Addendum #1

Project Name: Firethorn Office Building
Lincoln, NE
Project No.: 23015
Issued: July 17, 2023
Bid Date:
Bid Opening: Sinclair Hille Architects
Location: Lincoln, NE 68508

M100

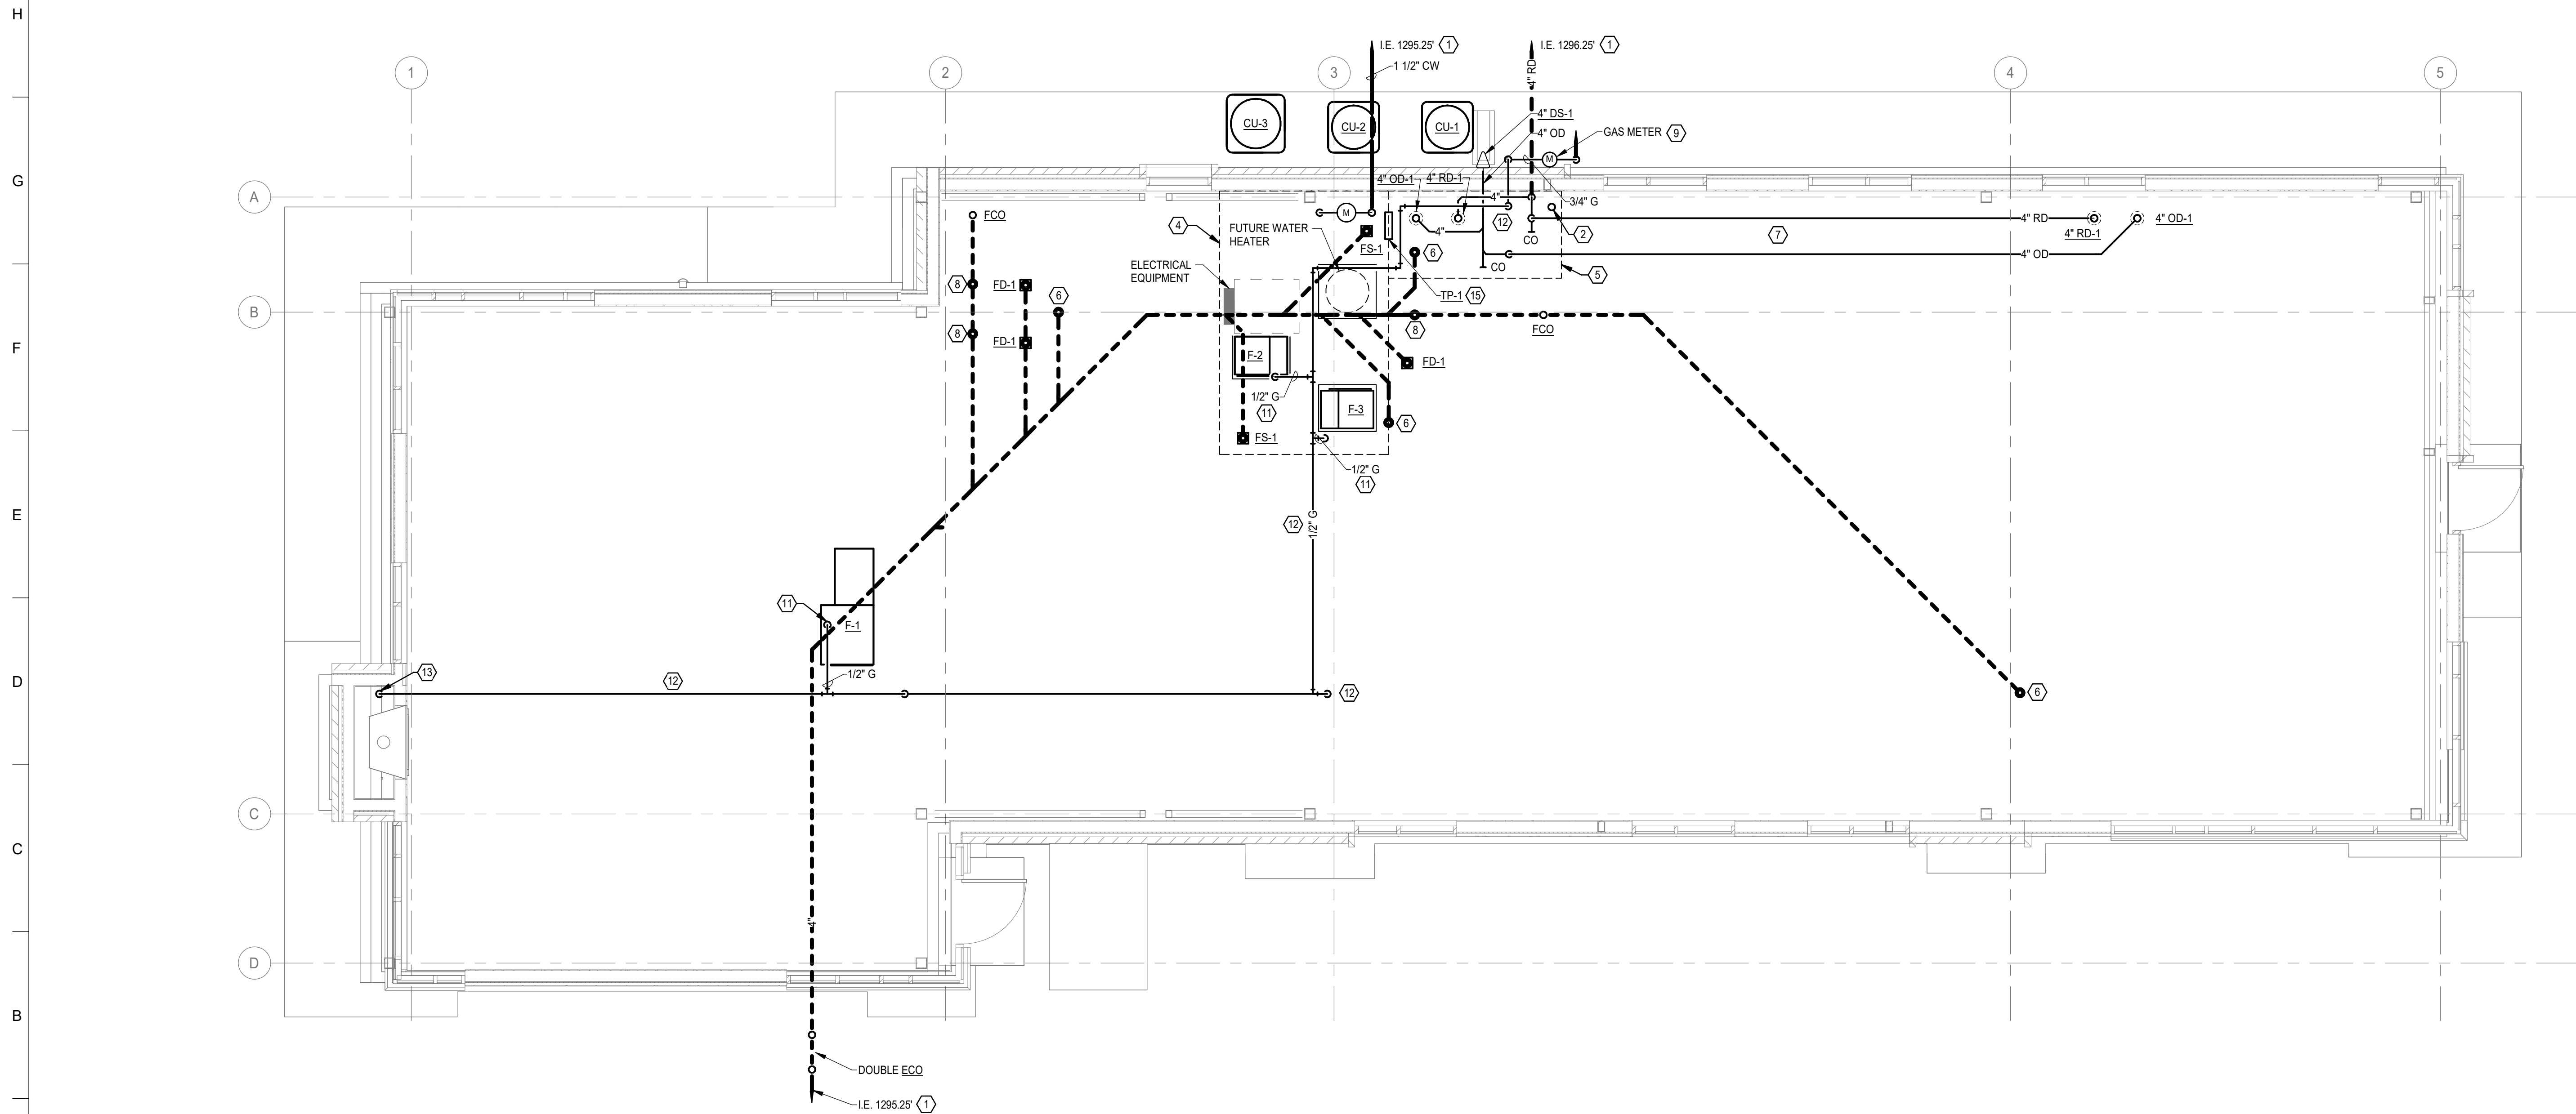
- ADD 1-1.** Sheet M100 – HVAC AND PLUMBING PLANS. Updated size of F-2 furnace unit.
- ADD 1-2.** Sheet M300 – MECHANICAL SCHEDULES AND SPECIFICATIONS. Updated furnace and condensing unit schedules for F-2 / CU-2.
- ADD 1-3.** Sheet E100 – ELECTRICAL FIRST FLOOR PLAN. Revised plan for revised furnace locations as shown.
- ADD 1-4.** Sheet E600 – ELECTRICAL SCHEDULES. Revised mechanical equipment connection schedule & Panel schedule HP1 for revised furnace & condensing unit selections as shown.
